**BEFORE THE BOARD OF PATENT APPEALS  
AND INTERFERENCES**

Application Number: 10/087,558  
Filing Date: February 28, 2002  
Appellant(s): DANDO ET AL.

**EXAMINER'S ANSWER**

**Fig. 1b**  
PRIOR ART

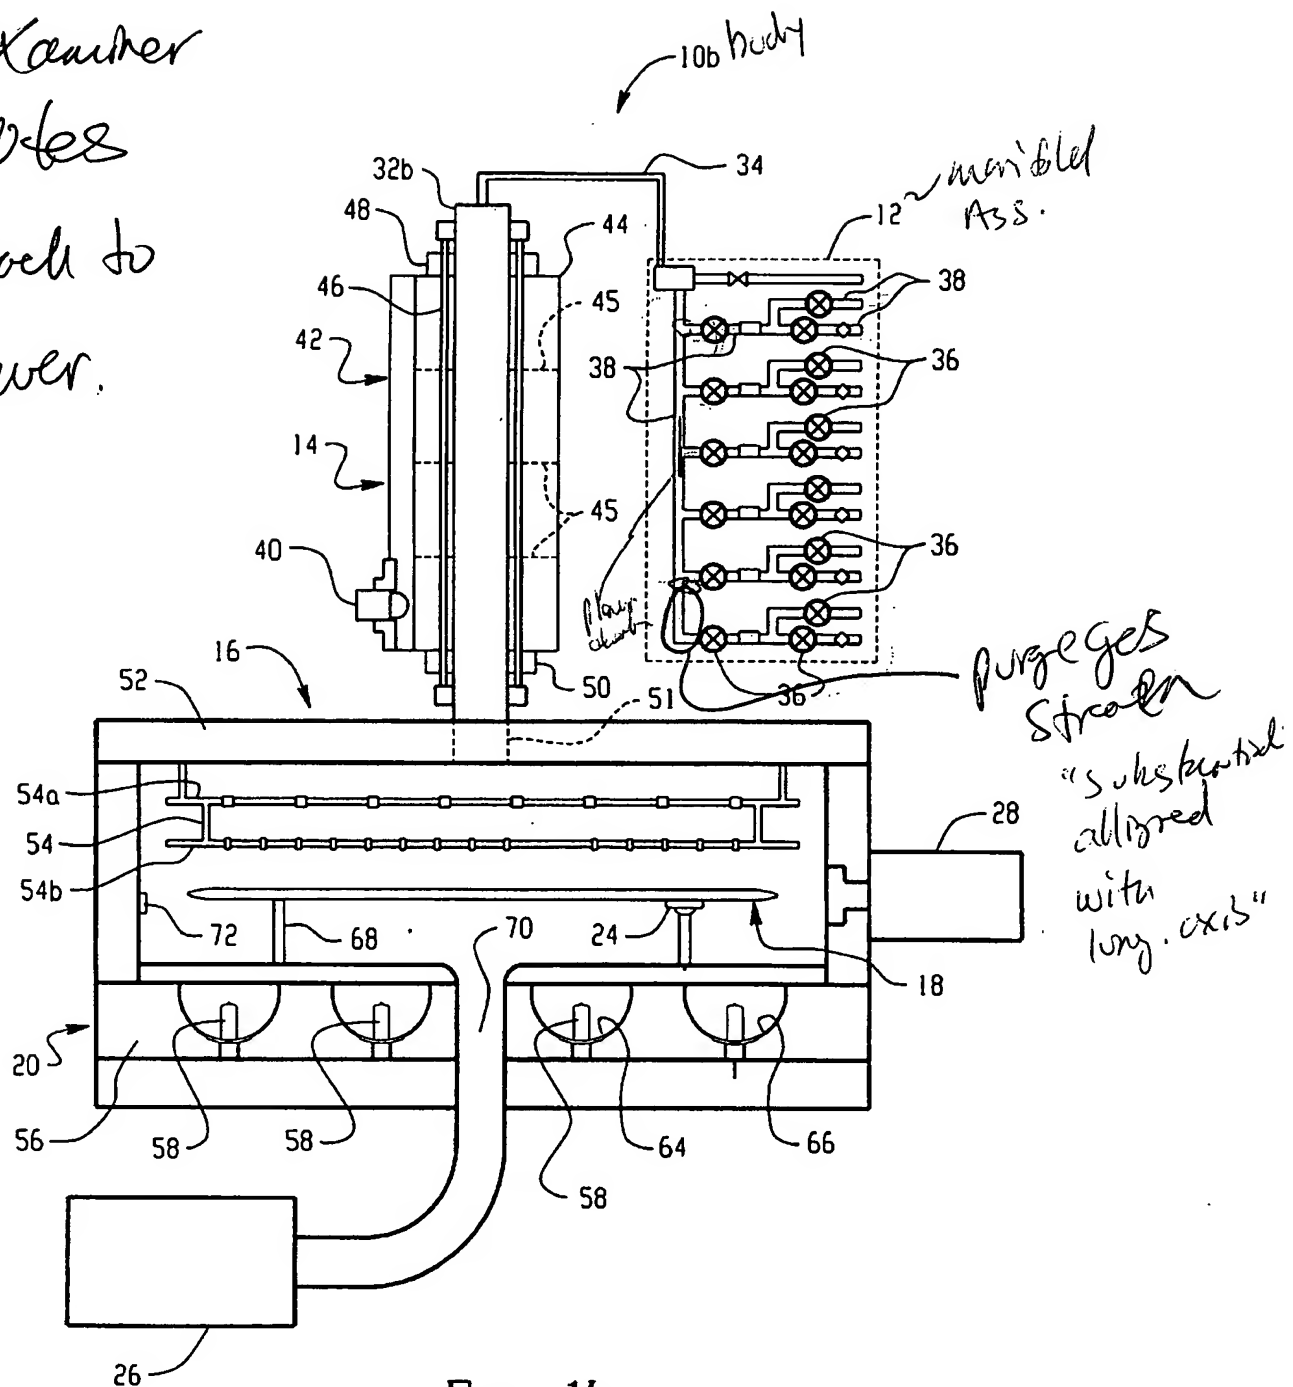
As repeatedly addressed above. Srivastava's "elongate body comprising an elongate plenum chamber" is the vertical left-most pipe 38 of Srivastava's Figure 1b. See the Examiner's notes. That Srivastava's vertical left-most pipe 38 of Srivastava's Figure 1b has a "first longitudinal axis end and a second longitudinal axis end " is taken from the orientation of the longitudinal axis of Srivastava's vertical left-most pipe 38 of Srivastava's Figure 1b.

As repeatedly addressed above, Srivastava teaches respective feed streams (immediate "T" branch point and upstream piping from left-most pipe 38 of Srivastava's Figure 1b) on the body (left-most pipe 38 of Srivastava's Figure 1b) feeding to the plenum chamber (left-most pipe 38 of Srivastava's Figure 1b) precursor inlets (oulets of "T" branch point from upstream piping

The Examiner has cited that Srivastava's purge gas stream (sixth, from top to bottom, gas stream feeding into Srivastava's body) including an elongated segment (piping for gas feeding connections to left-most pipe 38; Figure 1b) joining with Srivastava's purge gas inlet (sixth, from top to bottom, gas stream feeding into Srivastava's body) and which is substantially aligned on Srivastava's longitudinal axis (axis of left-most piping 38 of 12; Figure 1b) of the plenum chamber (inherent - needed to convey gases in 38). Inclusive, Applicant's Figure 1 piping configuration is identical, pictorially and in claimed structure, to Srivastava's piping arrangement of 12, Figure 1b.

*Examiner  
Notes  
Attach to  
Answer.*
